Addendum No. 1 to REBID IFB 24-43

To: Bidders of REBID IFB 24-43 Installation of Three (3) Standalone Portland Loo Prefabricated Toilets
From: Andrea Caruth, Deputy Chief Procurement Officer
Date: March 21, 2024 (Updated to include bid price form referenced in response to question #1)
Re: Responses to Requests for information

This addendum responds to requests for information.
This addendum adds the structural drawings and structural calculations noted on page 4.
This addendum updates the bid price form.
This addendum updates that the School Street dropbox is no longer available.

NAME	DATE	SERIAL NO.	DRW. NO.
EVAN	08/08/2022		S3.0

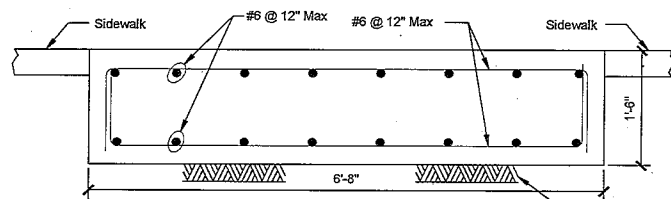
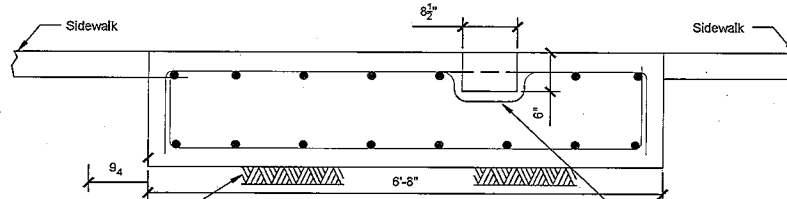
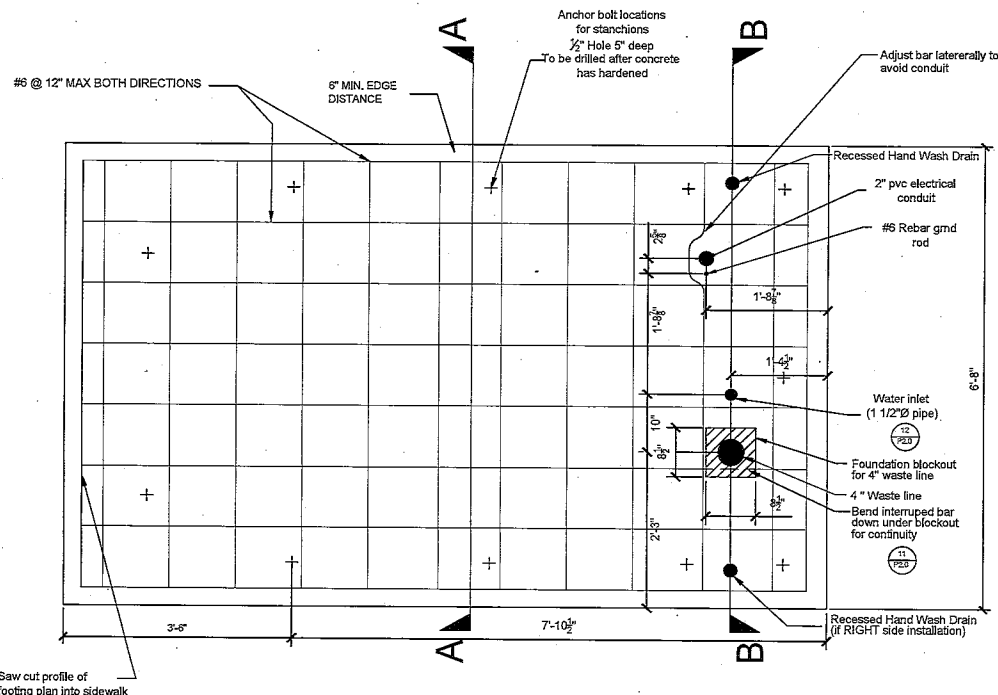
10. Please provide foundation details and specifications for the pre-fabricated structures.	See Sheet S3.0 of the attached document titled "Portland Loo Structural Drawings."
